Access Compliance Report

Public Rights-of-Way

Intersection ID: 15897	Main Street: LOCKHART_DR	Cross Street: CLAYTON_DR	Location: NW
ADA ID: 3CFAEFA7B59F	Ramp Type: PerpDiag	Initial Pass/Fail: Fail	Overall Compliance: No
		Severity Score: 10

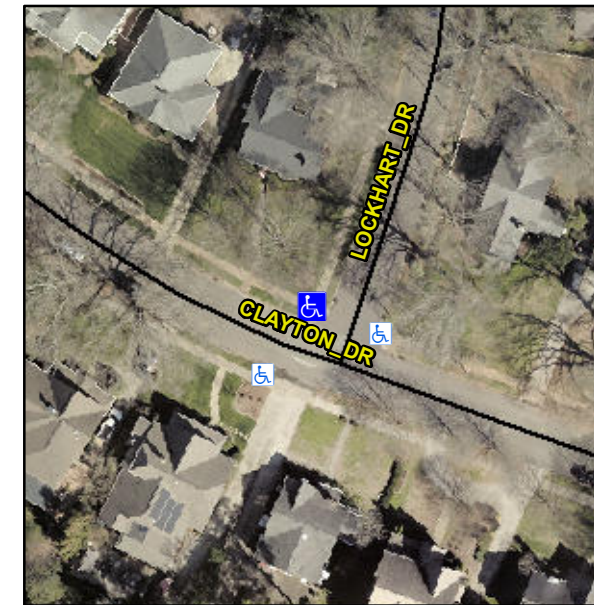
R304.5.1, R304.5.3

Compliance	Description	Data	Compliance	Description	Data
N/A	Ramp Length (in)	52.0	Yes	Ramp Slope (%)	6.3
No	Ramp Width (in)	43.0	No	Ramp XSlope (%)	2.2
N/A	Flare Type LT	N/A	N/A	Flare Type RT	N/A
N/A	Flare Slope LT (%)	N/A	N/A	Flare Slope RT (%)	N/A
N/A	Flare Traversable LT?	N/A	N/A	Flare Traversable RT?	N/A
N/A	Landing Length (in)	N/A	N/A	DWS Provided?	N/A
N/A	Landing Width (in)	N/A	N/A	DWS Contrast?	N/A
N/A	Landing Slope (%)	N/A	N/A	DWS Length (in)	N/A
N/A	Landing X Slope (%)	N/A	N/A	DWS Full Width?	N/A
N/A	Landing Curb? (Y/N)	N/A	N/A	DWS Offset (in)	N/A
N/A	Shared Landing?	N/A			
N/A	Gutter Ponding?	N/A	N/A	Gutter Slope (%)	N/A
N/A	Gutter Lip Ht (in)	N/A	N/A	Gutter X Slope (%)	N/A
N/A	Painted X Walk1?	No	N/A	Painted X Walk2?	No
	X Walk 1 Direction	To SW		X Walk 2 Direction	To SE
N/A	X Walk 1 Width (in)	N/A	N/A	X Walk 2 Width (in)	N/A
	X Walk 1 Slope (%)	0.9		X Walk 2 Slope (%)	3.5
	X Walk 1 X Slope (%)	3.4		X Walk 2 X Slope (%)	1.8

Remove & Replace Curb Ramp With Two New Directional Ramps or Equivalent.
